King's Cross Central Fish and Coal Offices, Application Nos. 2014/5272/P and 2014/5273/P

We have objections to the enlargement of stables windows facing the towpath beneath Block 5 and to the remodelling of the roof of Block 4 as a conservatory. Also comments about the parapet of Block 2 and reusing historic bollards. Sorry for late response.

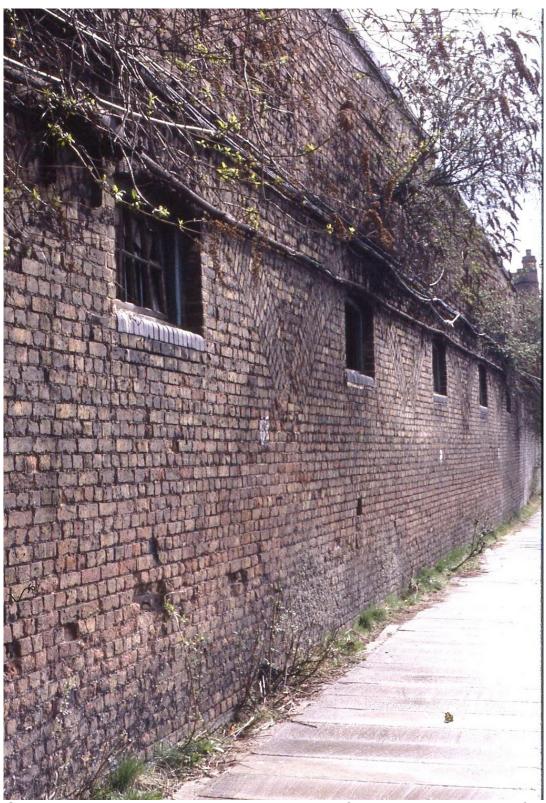
The Initial Conservation Plan quoted on p.17 of Urban Design Report suggests rebuilding the parapets in the pre-fire form might be considered. A pre-fire photo in the Conservation Plan shows that they originally projected further, modelled in

brickwork like a cornice, giving more majesty to this original Coal Office. Why has this not been followed through?

View from St Pancras Lock, showing cascade of slate roofs on Blocks 2, 3 and 4. Replacing the Block 4 roof by a glass box will be highly damaging, and will also create confusion in the townscape between old buildings and new.

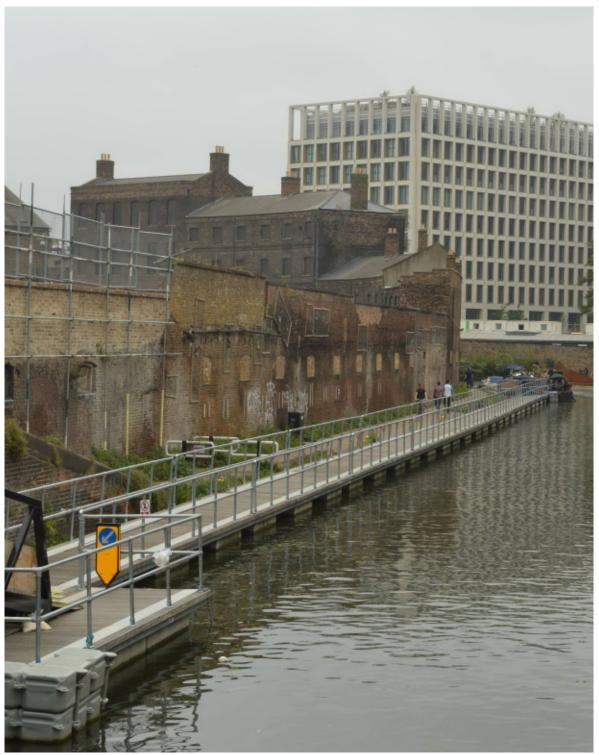
Note that views from the intended footbridge will be similar to this, becoming a key view.
